KEY DISCUSSION ISSUES:

DIRECTION RECEIVED FROM FEBRUARY 12TH DESIGN RESPONSE CONFERENCE

view southeast- before

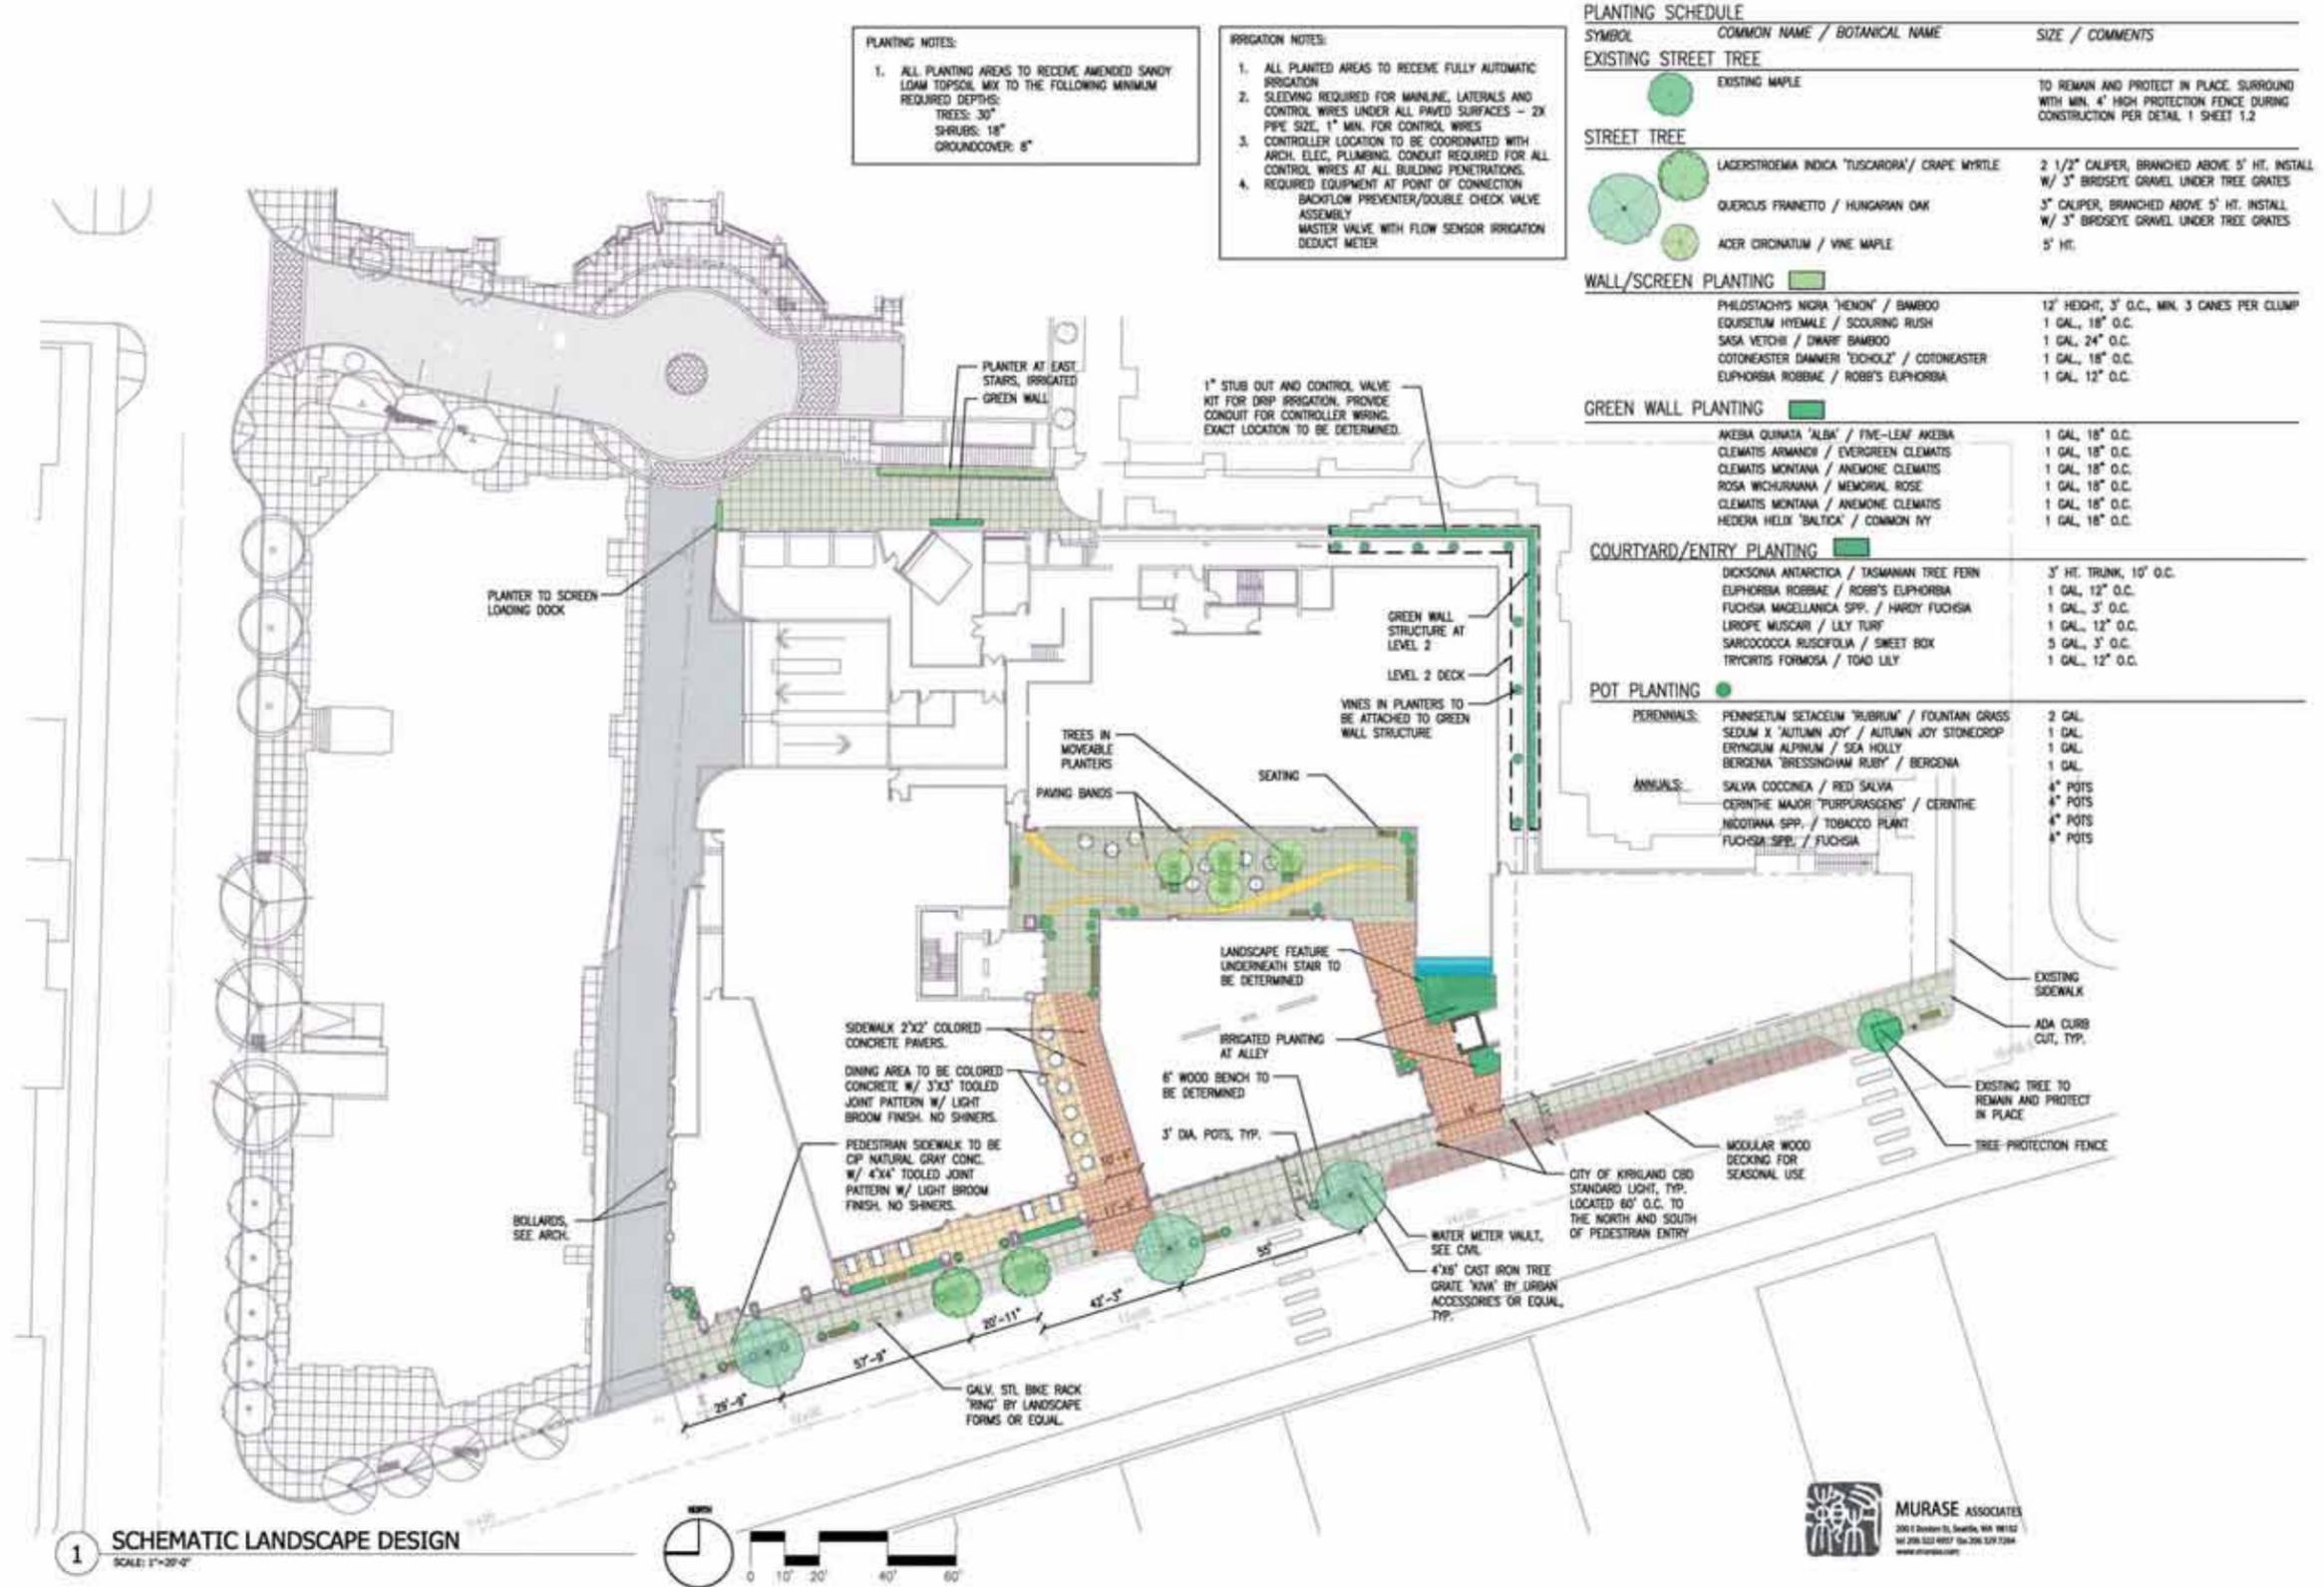
- 22. Added Green Screen frame at east elevation to provide visual buffer fro Portsmouth condominium
- 23. Revised planting for stair wall to provide planter on roof with "cascading" plant materials
- 24. Added green wire systems for climbing plant materials on southeast corner of building
- 25. Rotated Mechanical Screens on roof to east-west orientation to reduce visual impact on neighboring buildings
- 26. Moved "cooling tower" from east side of roof to northwest core to reduce visual impact on neighboring buildings
